Goodwyn Mills Cawood

SUBJECT: Addendum 2

PROJECT: Hillsboro School Renovations

This Addendum forms a part of the Contract Documents and modifies the original documents, released 12/18/2025.

CMU WALL OPENINGS

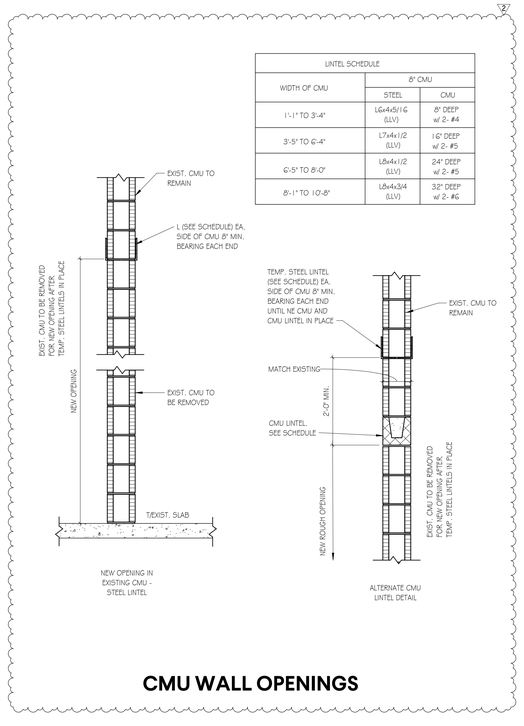
13. G1.21
    13.1. Updated stud and drywall partitions to go to deck.
    13.2. Added CMU wall opening detail.

06 CANOPY SECTION - ALTERNATE 1A

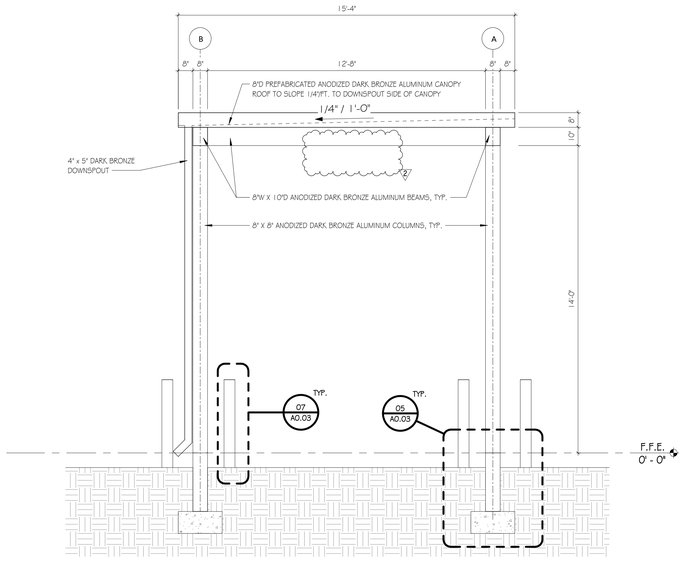
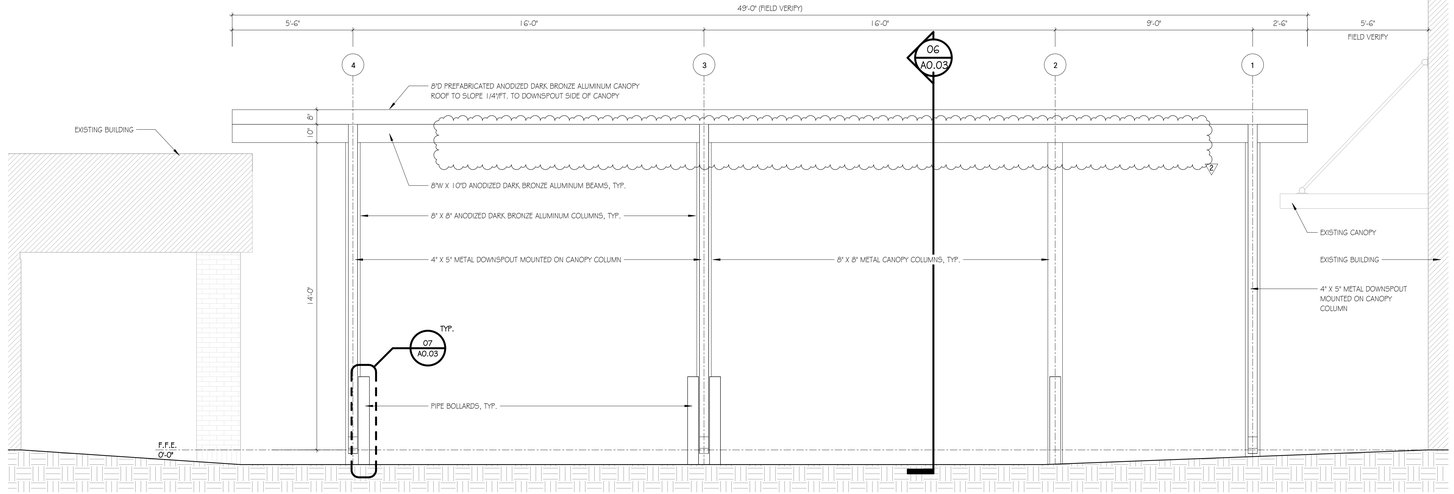
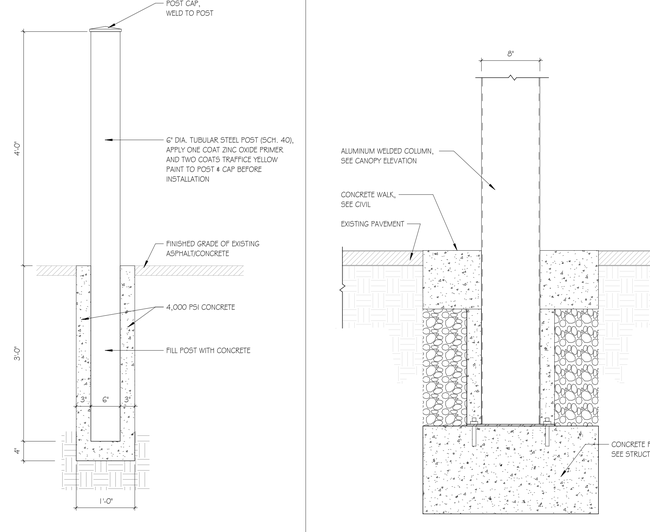
14. A0.00
    14.1. Revised sheet to reflect more accurately the scope of work associated with Base Bid.
15. A0.03
    15.1. Removed light fixtures from canopy.

107. Alternates 1A and 1B do not have electrical drawings for the canopies. They show lights to be installed with no legend for the fixtures. What type would they need to be and quantity?

116.1. Note has been removed from demo sheets. No ceiling work in these areas.
117. Please confirm the quantity of pipe bollards to be installed at the location of the new exterior canopy in Alternate 1A, as the exact quantity is not clear on drawing A0.03.

107.1. This is not an egress path. No lighting is required. Scope has been removed from sheet A0.03.

117.1. 16
118. The general notes – All furniture and equipment shown on plans shall be provided unless noted in BID. When it says “provided” I assume it is by “General Contract”. Please confirm whether we need to consider as GC or Owner.
    For example:
    Nurse 15 / Teacher Lounge 55 – Ice maker, (is this C.F.C.I)?
    White Boards / TV’s / Tack Boards, are these C.F.C.I ?

07 NURSE 15 CASEWORK
SCALE: 3/8" = 1'-0"

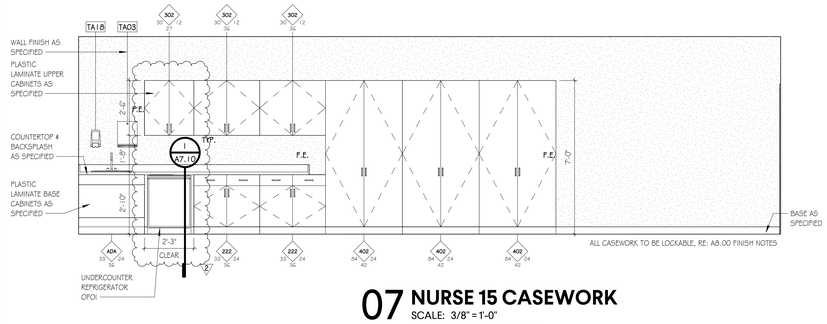
17.3. Changed all Type N doors to be Type NC.
18. A7.01
    18.1. Added note that all paper dispensers and soap dispensers are to be OFCI.
    18.2. Revised elevation 09 and 07.

132. Detail 07/A7.01 notes that the casework in room "Nurse 15" is to be plastic laminate, however specification section 12 35 53 - Laboratory Casework notes that the casework material is to be Maple. Please advise on the correct material type for the casework in room Nurse 15, and where/if wood casework is intended to be utilized.

01 REFLECTED CEILING PLAN - PART A PHASE 1

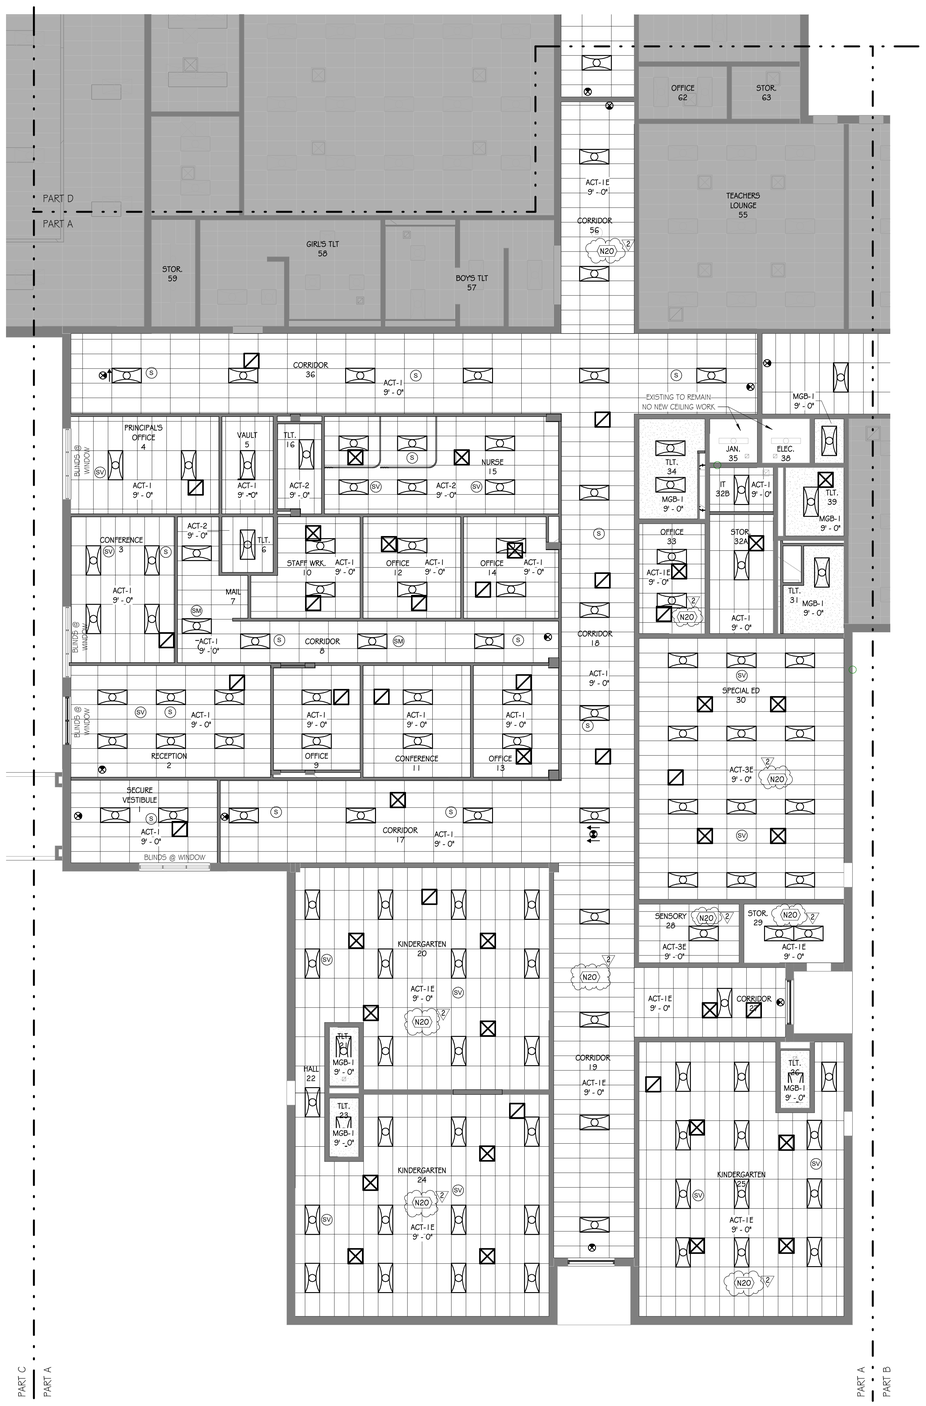
25.1. Added note that all paper dispensers and soap dispensers are to be OFCI.
26. 1-A2.01
    26.1. Corrected ceiling keynotes.
27. 1-A2.02
    27.1. Corrected ceiling keynotes.

01 ENLARGED PLAN - SCIENCE
SCALE: 1/4" = 1'-0"

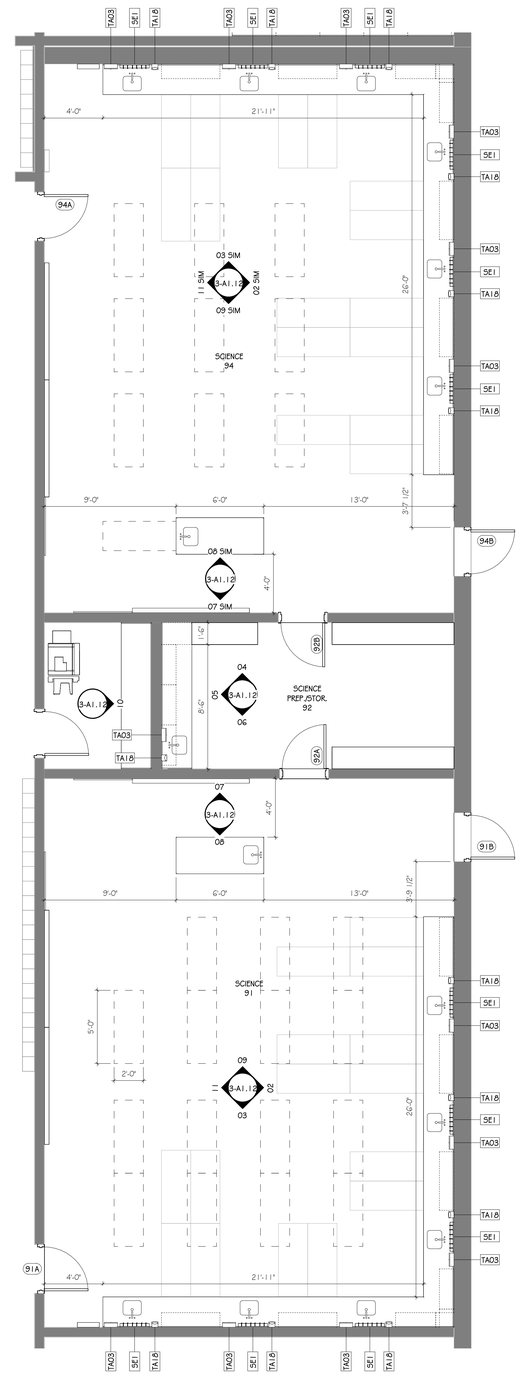
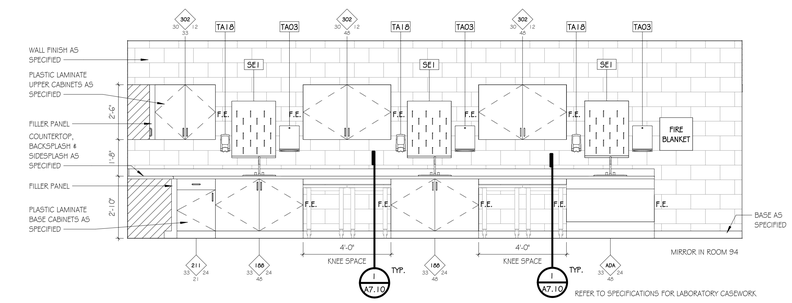
50. 3-A1.12
    50.1. Added note concerning rolling science lab tables.
51. 3-A2.02
    51.1. Corrected ceiling keynotes.

1 ELECTRICAL LIGHTING FLOOR PLAN - PART E - PHASE 1
SCALE 1/8" = 1'-0"
0 4' 8' 16'

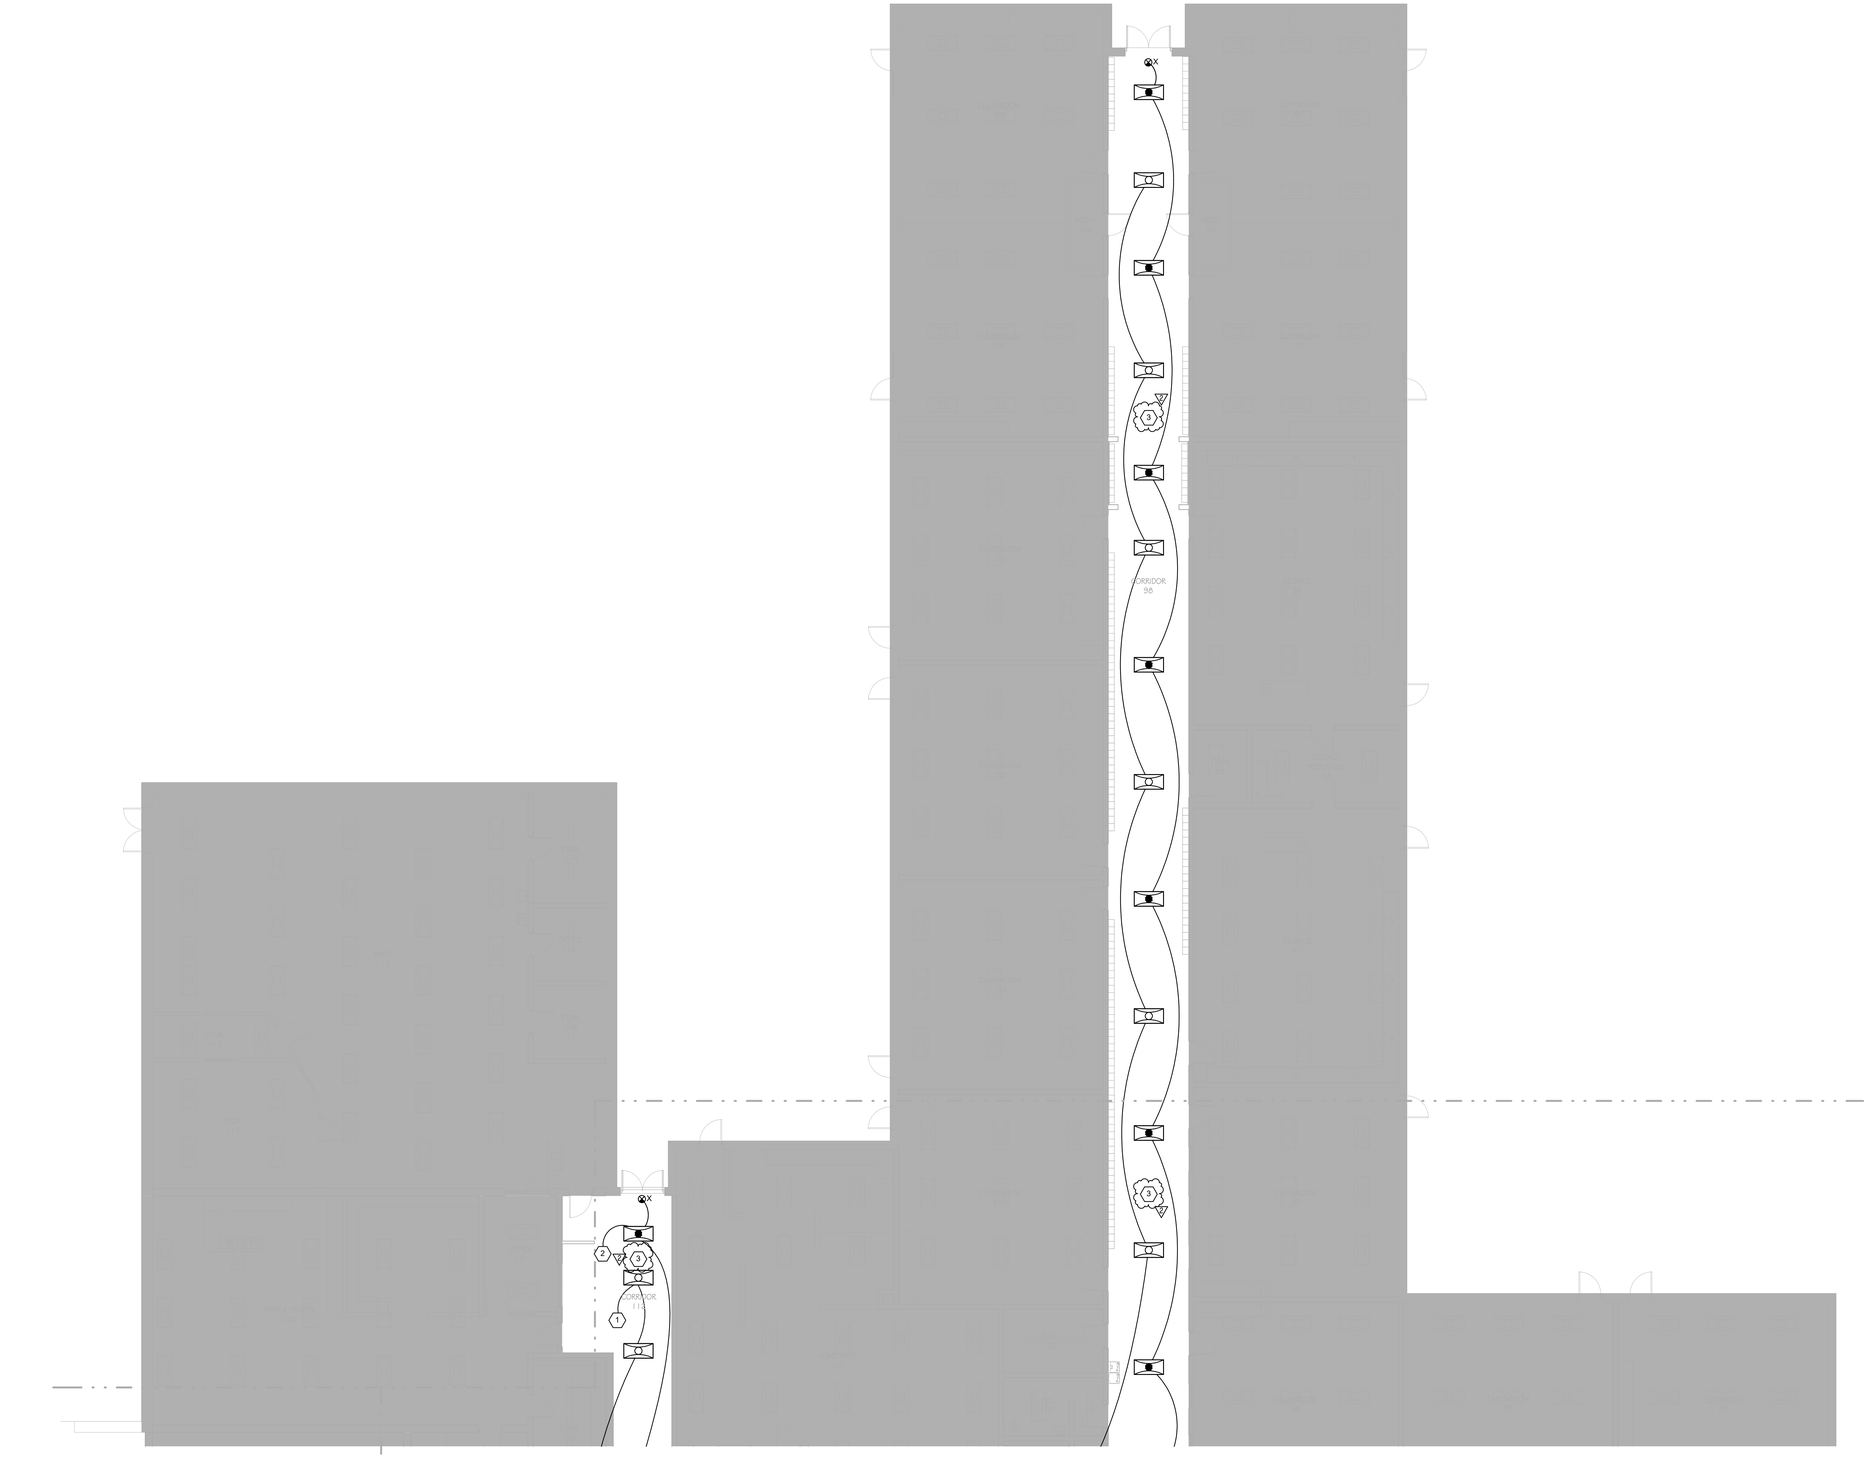
88.2. Offices 71, 72, and Corridors shall have reused lighting. Added keyed note 3.
89. 1-E2.01E
    89.1. Added general note I.
    89.2. Corridors shall have reused lighting. Added keyed note 3.

01 ELECTRICAL LIGHTING FLOOR PLAN - PART E - PHASE 3
SCALE 1/8" = 1'-0"
0 4' 8' 16'
PLAN NORTH TRUE NORTH

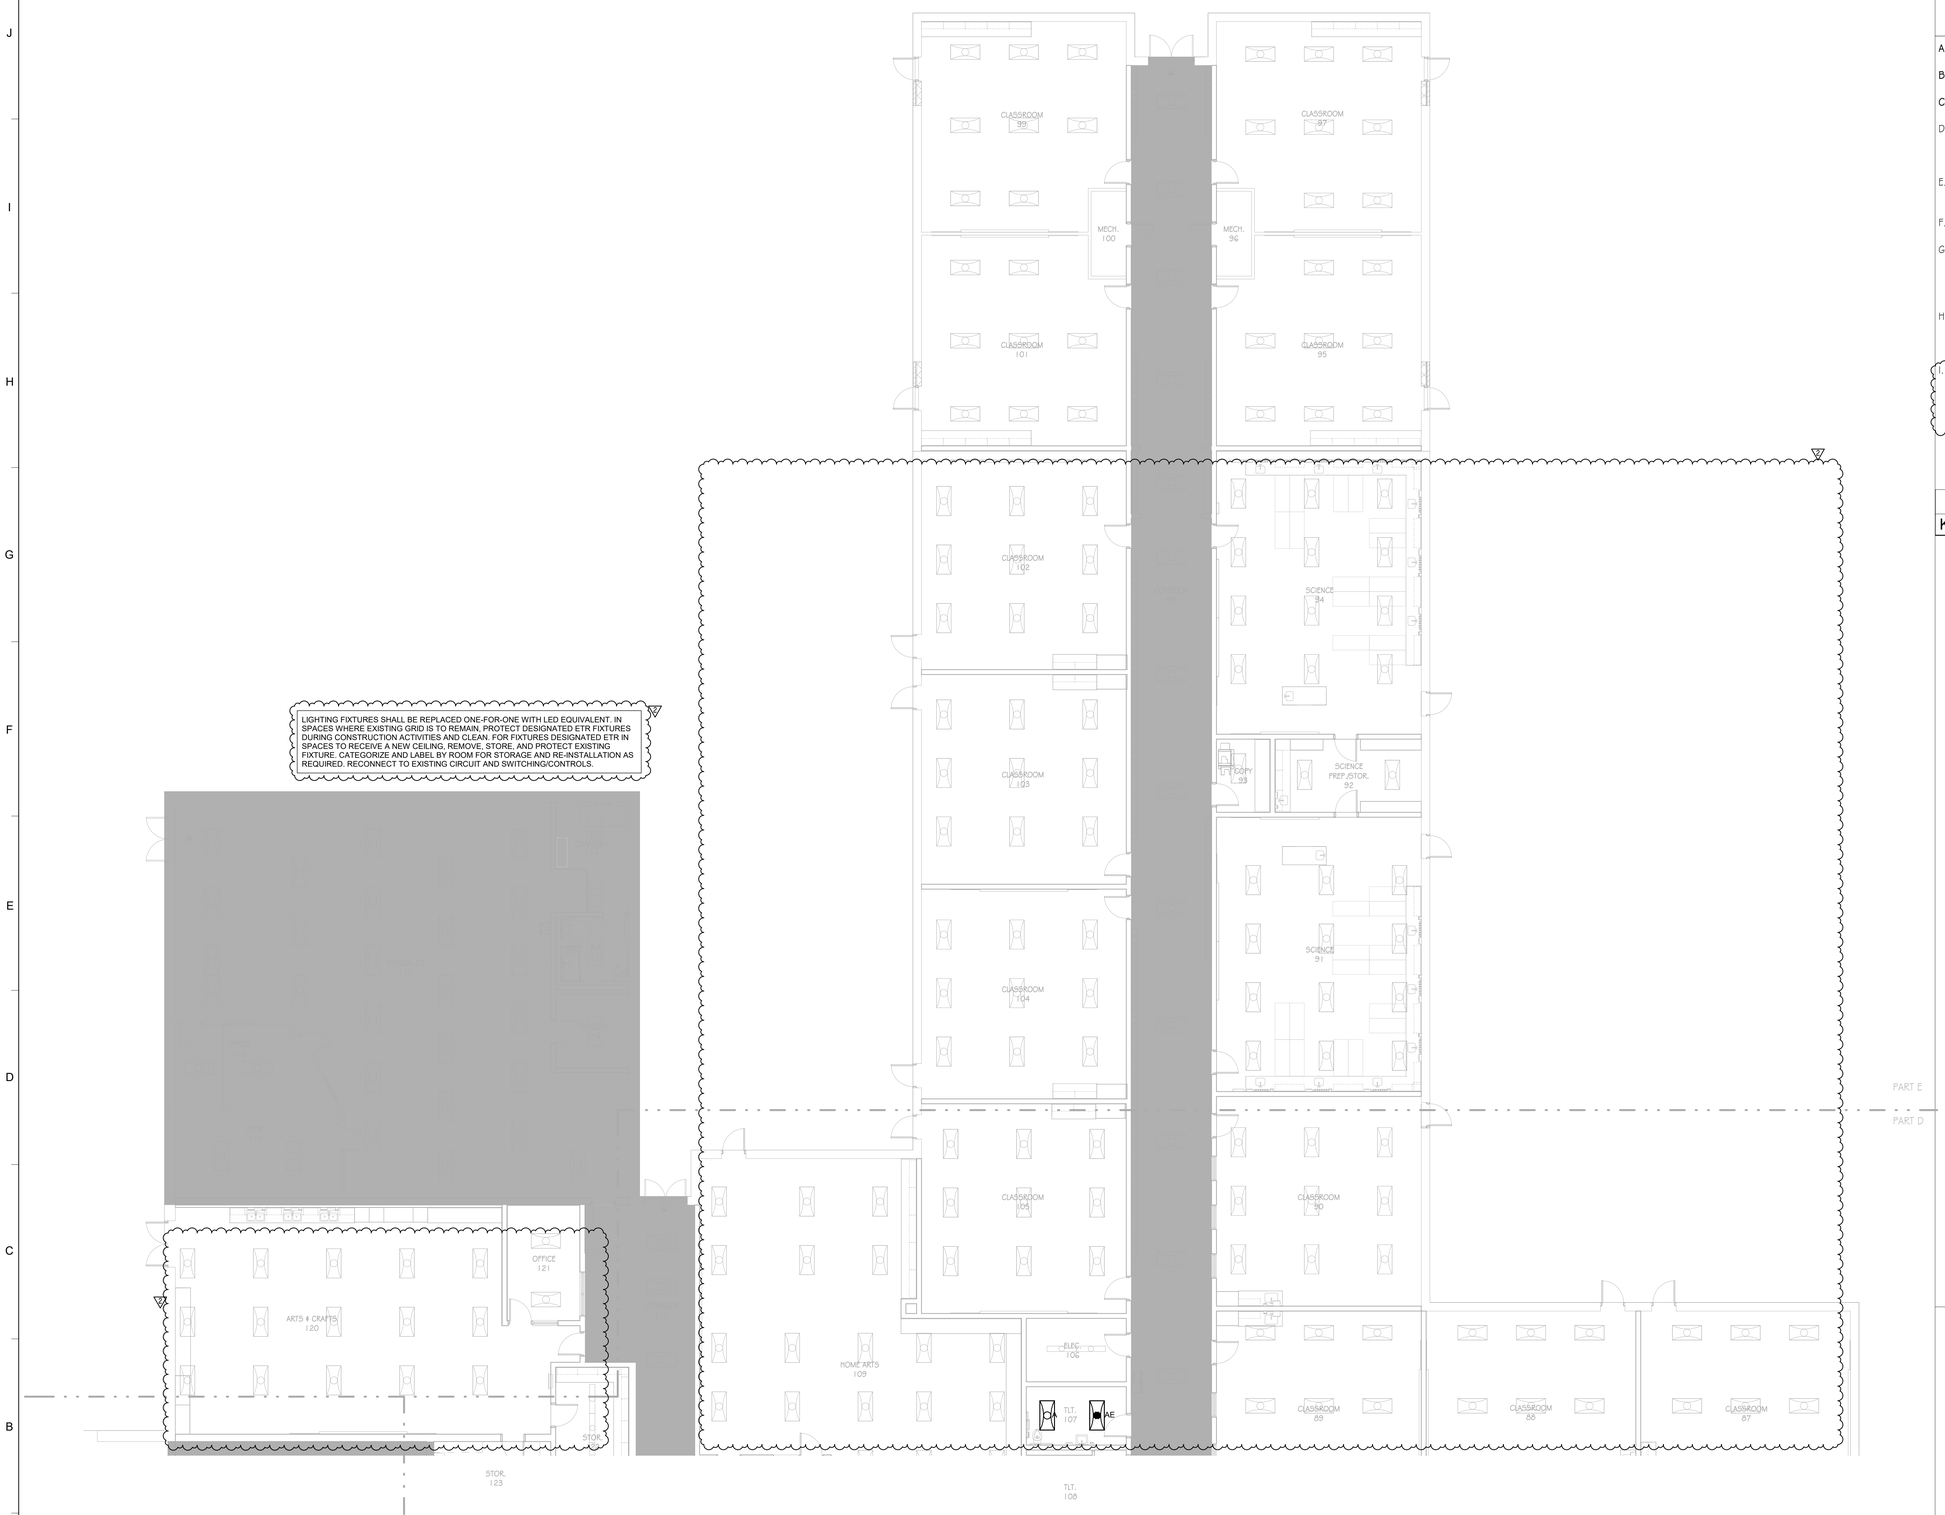
98. 3-E1.01
    98.1. Updated general notes E & H.
    98.2. Updated boxed floor plan note regarding existing to remaining fixtures.
    98.3. Existing fixtures to be reused and remain throughout.
99. 3-E2.01A
    99.1. Removed sheet from project.
100. 3-E2.01C
    100.1. Added general note I.
    100.2. Updated boxed floor plan note regarding existing to remaining fixtures & controls.
    100.3. Office, Rec, and Commons lighting ETR.
101. 3-E2.01D
    101.1. Added general note I.
    101.2. Updated boxed floor plan note regarding existing to remaining fixtures & controls.
    101.3. Classroom and Home Arts lighting ETR.
102. 3-E2.01E
    102.1. Added general note I.
    102.2. Updated boxed floor plan note regarding existing to remaining fixtures & controls.
    102.3. Classrooms and Arts Rooms lighting ETR.
